**Timing Chain Guide Elimination On
1991-93 1.6L DOHC Nissan Engines**

The AERA Technical Committee has received information concerning the elimination of two timing chain guides on 1991-93 1.6L DOHC engines. Beginning with engines produced in March 1993, the top and left side timing chain guides were eliminated.

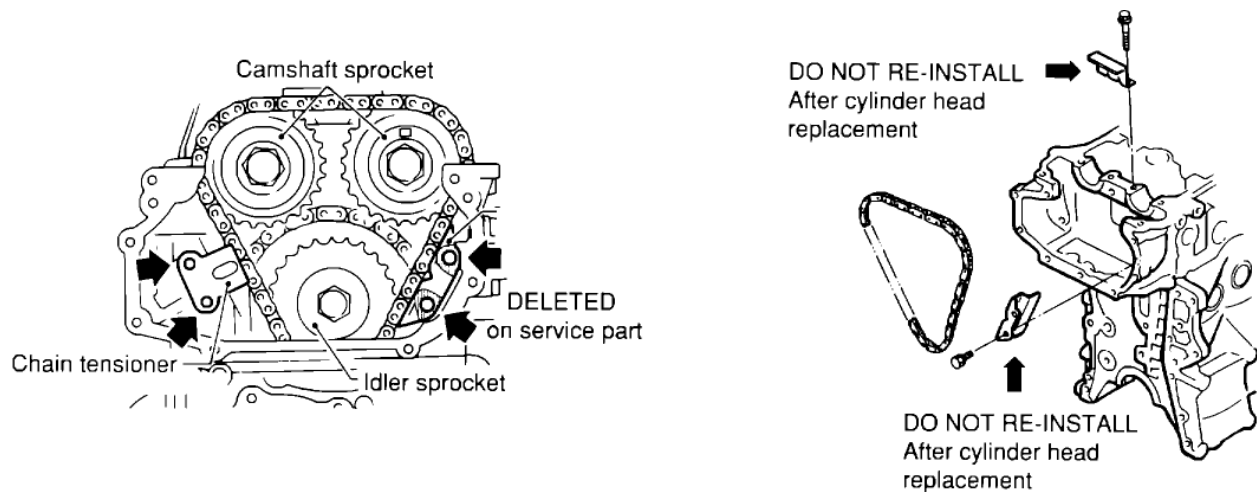
All replacement cylinder heads Part #11040-57Y01, will not have the drilled holes to attach the chain guides. Those guides are not necessary and may cause an undesirable rattling noise when the timing chain contacts the guide. To prevent a possible noise complaint, Nissan suggests removing the two guides shown in the illustrations below anytime cylinder head repair is done.
